# MIAMI BEACH

### Staff Report & Recommendation

### Design Review Board

SUBJECT: DRB17-0203  
**5709 La Gorce Drive**

1941 aerial

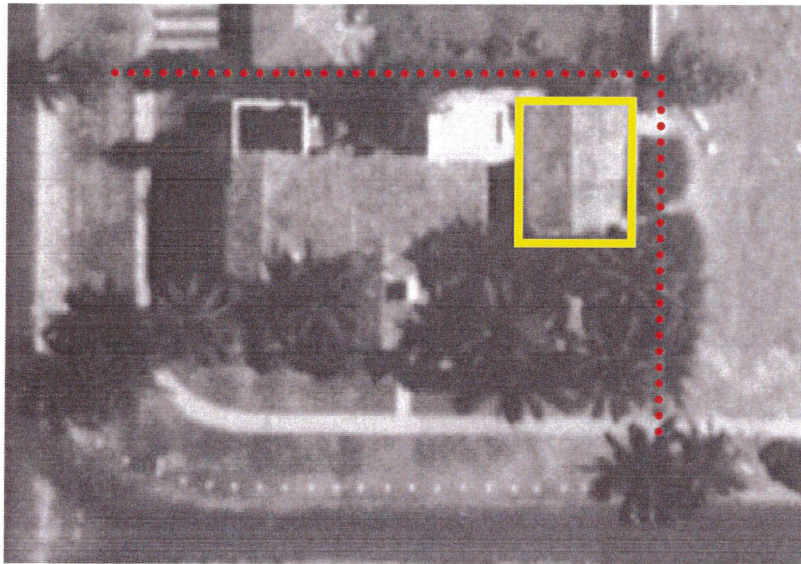
Variances #1 and #2 are fundamentally linked to one another as they pertain to the minimum required interior side and rear yard setbacks for the reconstruction of the new two-story addition. The new construction will follow the non-conforming interior side (north) and rear (east) setback footprint of the existing structure. The existing garage portion was built in wood frame construction in 1925. As the owner was preparing some exploratory demolition in preparation for a complete interior renovation and remodeling project, severe structural deficiencies were discovered in those portions of the wood structure that connected to the primary residence. The applicant is proposing to remove and rebuild a portion of the residence in roughly the same footprint and area. Staff is supportive of the variances requested. The new footprint, although requiring setback variances, is proposed in a manner that is compatible with the architecture of the building and with minimum impact on the architecturally significant home, originally constructed in 1925. Staff finds that these conditions and the retention of the structure create practical difficulties that result in the requested variances; as such staff supports variance requests #1 and #2.
